# Access Compliance Report

## Public Rights-of-Way

Intersection ID: 14278	Main Street: ROMARE_BEARDEN_DR	Cross Street: FARMER_ST	Location: W
ADA ID: 4807BD980EFD	Ramp Type: MedianPerp	Initial Pass/Fail: Pass	Overall Compliance: No
Severity Score: 12.75			
Codes/Mitigation Info/Possible Solution		Field Measurements/Component Compliance

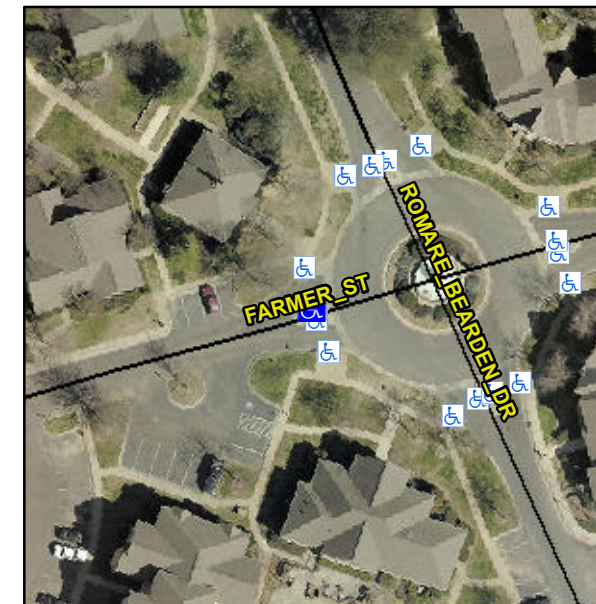
**Not Found, R304.5.3, R304.2.1, R304.2.2-Perp, R304.3.2-Para, R305.1.4, R305.2**

Compliance	Description	Data	Compliance	Description	Data
N/A	Ramp Length (in)	43.0	Yes	Ramp Slope (%)	6.1
Yes	Ramp Width (in)	58.0	No	Ramp XSlope (%)	3.8
N/A	Flare Type LT	Sloped	N/A	Flare Type RT	N/A
N/A	Flare Slope LT (%)	5.8	Yes	Flare Slope RT (%)	6.2
N/A	Flare Traversable LT?	Yes	N/A	Flare Traversable RT?	Yes
No	Landing Length (in)	N/A	Yes	DWS Provided?	Yes
No	Landing Width (in)	N/A	Yes	DWS Contrast?	Yes
No	Landing Slope (%)	N/A	Yes	DWS Length (in)	24.5
No	Landing X Slope (%)	N/A	No	DWS Full Width?	No
N/A	Landing Curb? (Y/N)	N/A	No	DWS Offset (in)	9.0
N/A	Shared Landing?	No			
Yes	Gutter Ponding?	No	Yes	Gutter Slope (%)	3.5
Yes	Gutter Lip Ht (in)	0.0	Yes	Gutter X Slope (%)	1.3
N/A	Painted X Walk1?	No	N/A	Painted X Walk2?	N/A
	X Walk 1 Direction	To N		X Walk 2 Direction	N/A
N/A	X Walk 1 Width (in)	N/A	N/A	X Walk 2 Width (in)	N/A
	X Walk 1 Slope (%)	1.2		X Walk 2 Slope (%)	N/A
	X Walk 1 X Slope (%)	1.3		X Walk 2 X Slope (%)	N/A

**Remove & Replace Entire Ramp.**
